SUBJECT: **New Vehicle Delivery Hold - Compliance Recall 24C08**
 Certain 2024 Model Year Maverick Vehicles
 TREAD Label Installation

Compliance Recall 24C08

CERTAIN 2024 MODEL YEAR MAVERICK VEHICLES — TREAD LABEL REPLACEMENT

FIGURE 1

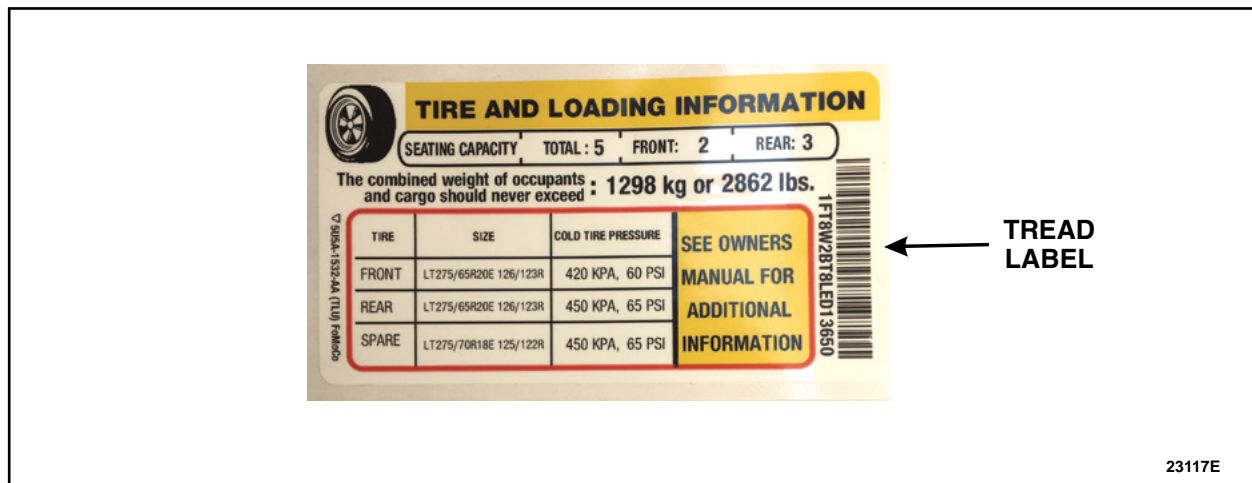
2. For In-Stock units, open the drivers door to see the TREAD label on the door jamb. Confirm the VIN on the *new* label matches the VIN on the vehicle. See Figure 1.

- If the VIN does not match, contact the SSSC before proceeding with this program to order a *new* VIN specific label.

FIGURE 2

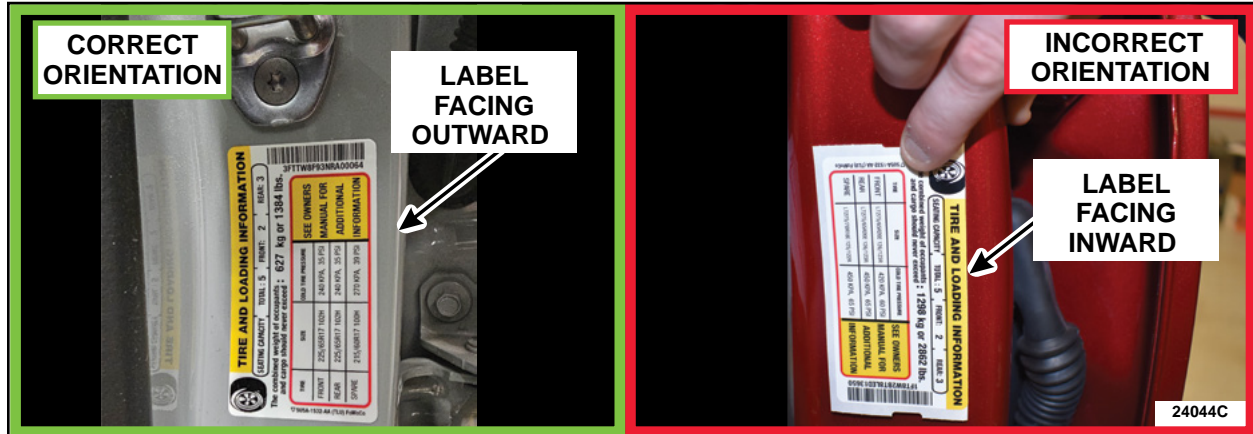
- Using a clean cloth and isopropyl alcohol, remove any residue from on and around the original label on the B-Pillar.
- Note the orientation of the original Tire and Loading Information (TREAD) label.
- Install the *new* label over the original TREAD label, in the same location and orientation. See Figure 2.

FIGURE 2

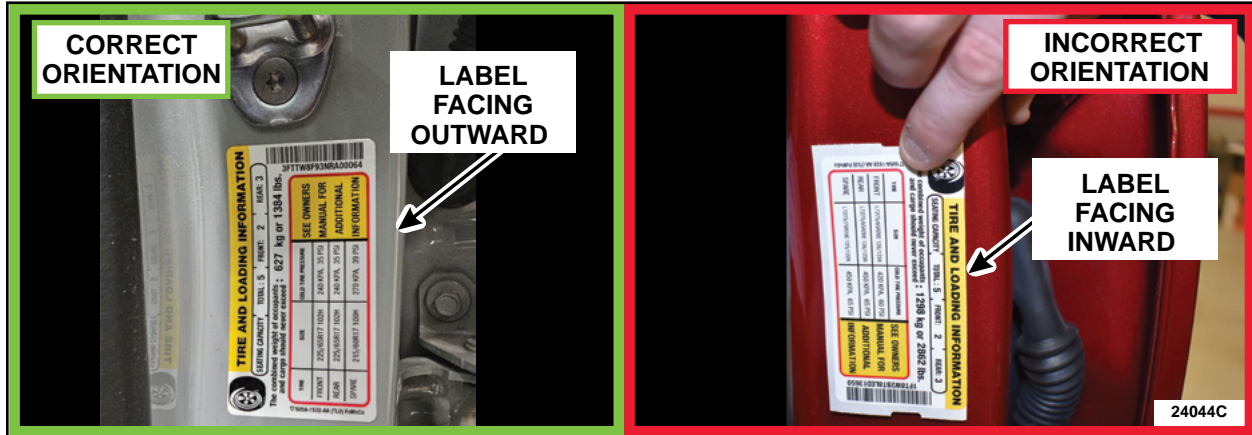
5. Install the *new* label **OVER** the original label, in the same location and orientation. See Figure 2.
